SAN FRANCISCO UNIFIED SCHOOL DISTRICT  
2011 PROPOSITION A BOND PROGRAM  
**Paul Revere School Modernization and Interim Housing**

**ADDENDUM NO. 1**

**PROJECT:** Paul Revere School  
Modernization and Interim Housing  
555 Tompkins Avenue  
San Francisco, CA 94110

**DATE:** March 25, 2015  
**DSA File No. 38-1**  
**DSA APP. No. 01-114431 & 01-114528**

# ESK-02

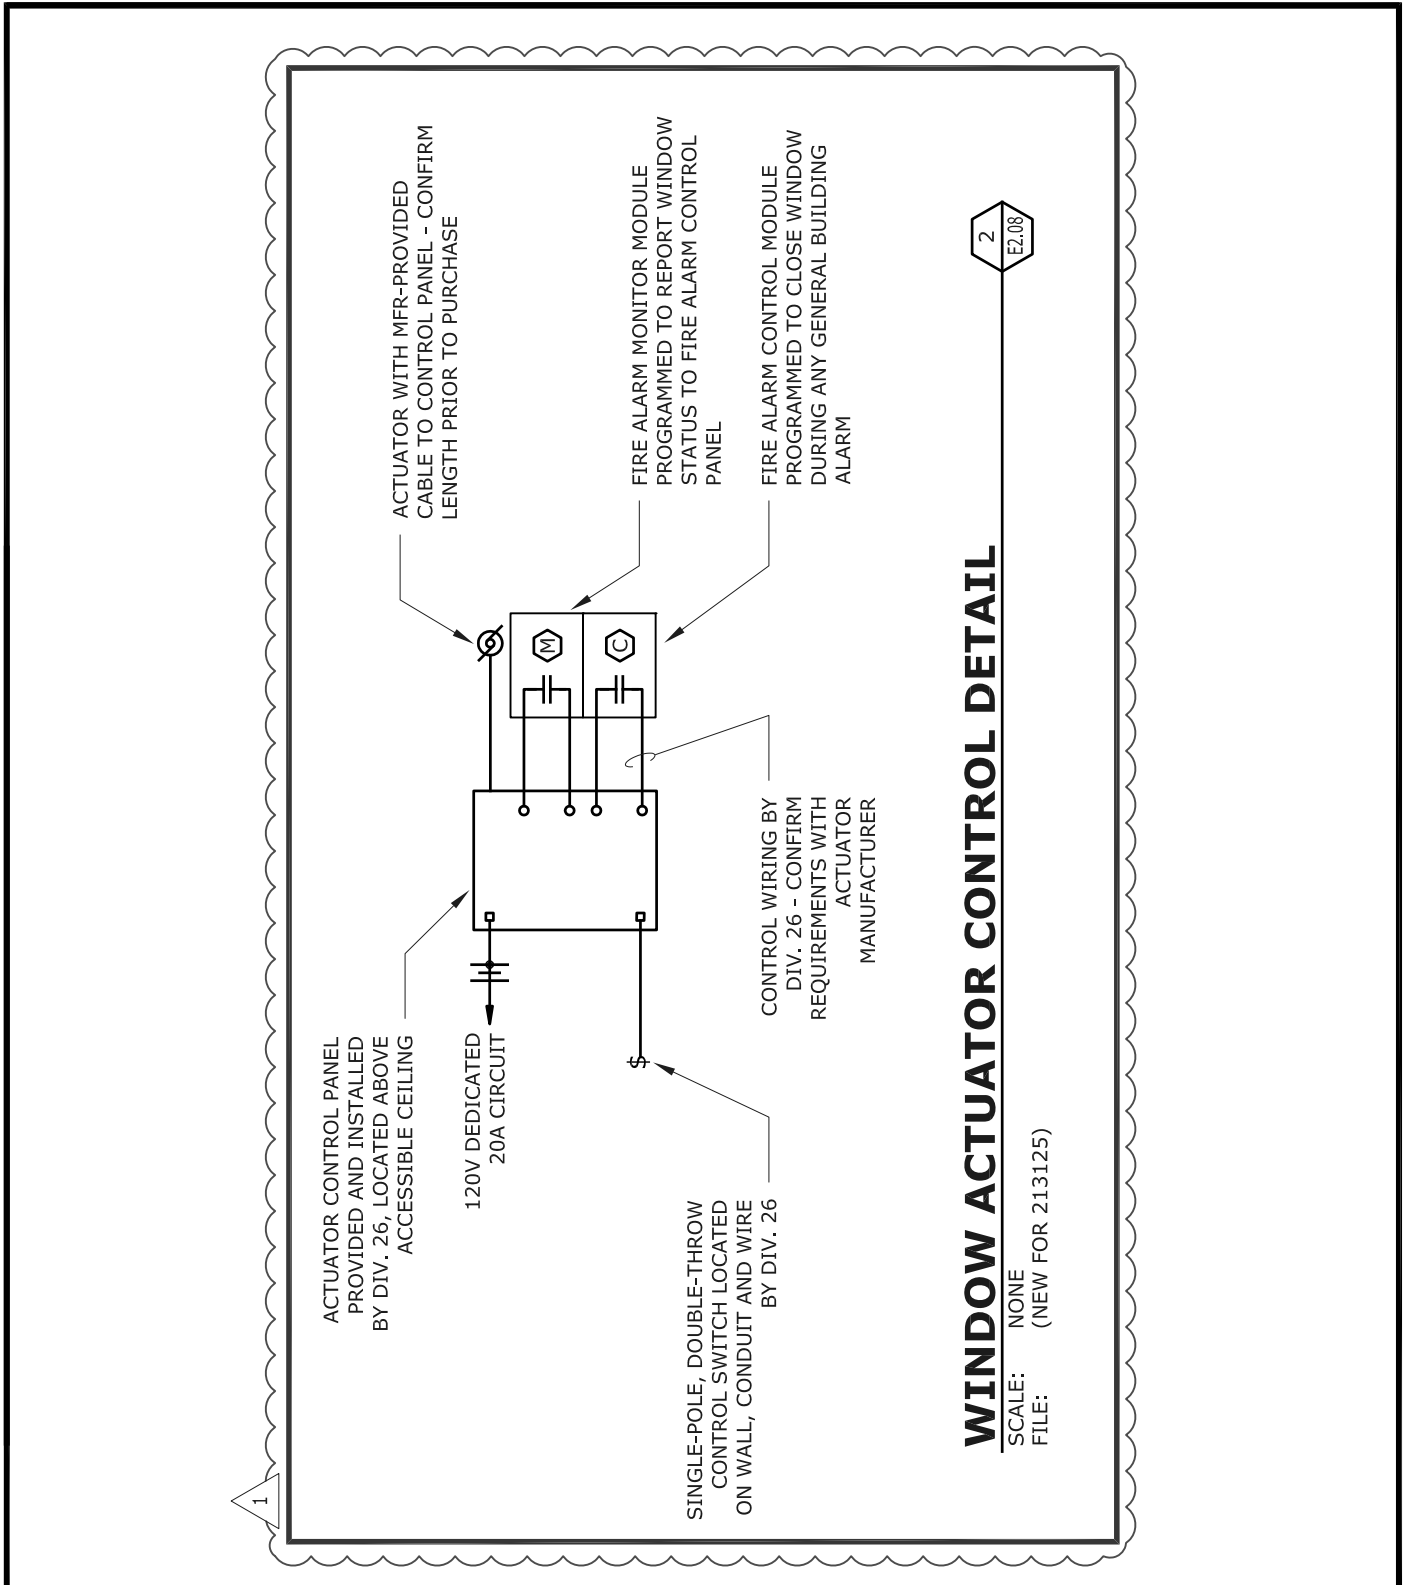
**Description:** Revise sheet E2.08 note 2 per ESK-02, to read: "MOTORIZED WINDOW - COORDINATE EXACT REQUIREMENTS WITH ARCHITECT PRIOR TO ROUGH-IN. PROVIDE AND INSTALL CONTROL PANEL (FFI #CP-4RQ-20ADC-UL OR EQUAL) ABOVE ACCESSIBLE CEILING IN STAFF LOUNGE 205 AND CONNECT ACTUATOR COMPLETE USING MANUFACTURER-PROVIDED CABLE IN 3/4"C. - COORDINATE WITH MFR. TO PROVIDE LENGTH OF CABLE AS NEEDED. CONNECT CONTROL PANEL COMPLETE TO FIRE ALARM SYSTEM CONTROL MODULE PROGRAMMED TO CLOSE WINDOW UPON BUILDING ALARM - SEE E2.07, FA2.07, AND 2/E2.08."

2 MOTORIZED WINDOW - COORDINATE EXACT REQUIREMENTS WITH ARCHITECT PRIOR TO ROUGH-IN. PROVIDE AND INSTALL CONTROL PANEL (FFI #CP-4RQ-20ADC-UL OR EQUAL) ABOVE ACCESSIBLE CEILING IN STAFF LOUNGE 205 AND CONNECT ACTUATOR COMPLETE USING MANUFACTURER-PROVIDED CABLE IN 3/4" C. - COORDINATE WITH MFR. TO PROVIDE LENGTH OF CABLE AS NEEDED. CONNECT CONTROL PANEL COMPLETE TO FIRE ALARM SYSTEM CONTROL MODULE PROGRAMMED TO CLOSE WINDOW UPON BUILDING ALARM - SEE E2.07, FA2.07, AND 2/E2.08.

**ESK-03**

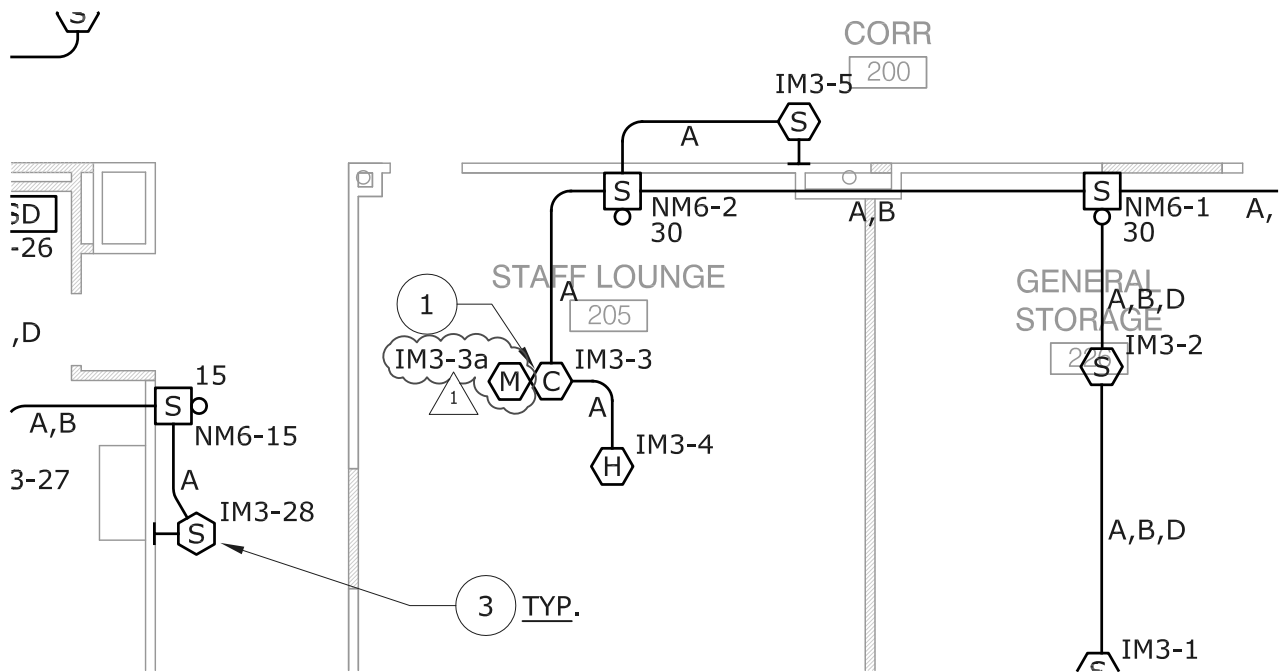
4. Item No. DWG-4  
Reference: **E2.08 - Main – Roof Plan – Power & Signal**  
Description: Add Detail 2/E2.08 per **ESK-03**– Window Actuator Control Detail  
Attachment: **ESK-03**

# ESK-04

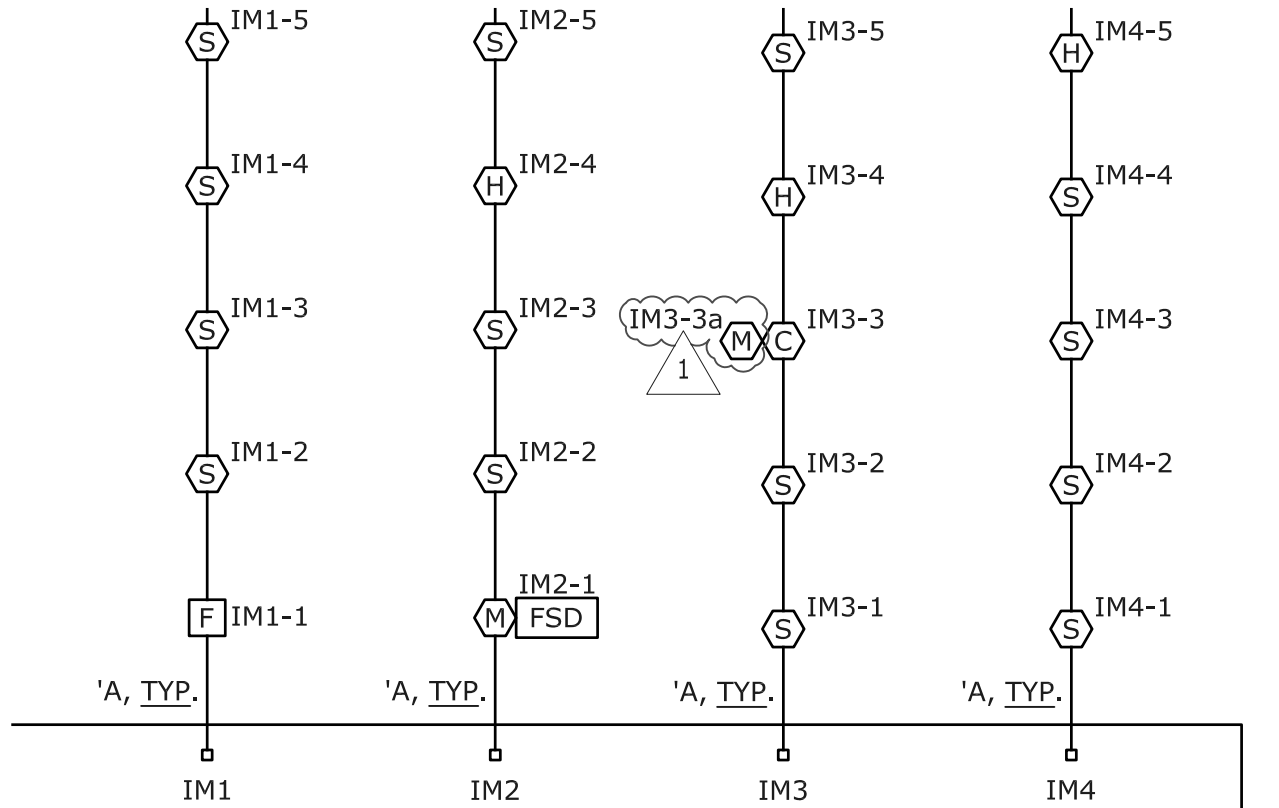
5. Item No. DWG-5  
Reference: **FA2.07 - Main – Second Floor Plan – Fire Alarm Plan – Sheet Note 1**  
Description: **Revise sheet note 1 per ESK-04 to read: “CONTROL MODULE AND MONITOR MODULE ABOVE FOR MOTORIZED WINDOW OPERATOR. CONNECT COMPLETE TO WINDOW CONTROL PANEL AND PROGRAM TO CLOSE WINDOW UPON BUILDING ALARM. SEE 2/E2.08.”**  
Attachment: **ESK-04**

- 1 CONTROL MODULE AND MONITOR MODULE ABOVE FOR MOTORIZED WINDOW OPERATOR. CONNECT COMPLETE TO WINDOW CONTROL PANEL AND PROGRAM TO CLOSE WINDOW UPON BUILDING ALARM. SEE 2/E2.08.
- 2 ELEVATOR SYSTEM FIRE ALARM DEVICES - SEE 4/FA4.01 FOR COMPLETE REQUIREMENTS.
- 3 WALL-MOUNTED SMOKE DETECTOR MOUNTED IN COMPLIANCE WITH NFPA72 17.6.3.1.3.1 - TYPICAL IN ALL CORRIDORS TO AVOID DISTURBING HAZARDOUS MATERIALS IN CORRIDOR CEILINGS. SAME MODEL AS CEILING-MOUNTED DETECTORS - PROVIDE ANY NEEDED MOUNTING ACCESSORIES FOR WALL-MOUNT INSTALLATION. SEE 5/FA4.01.
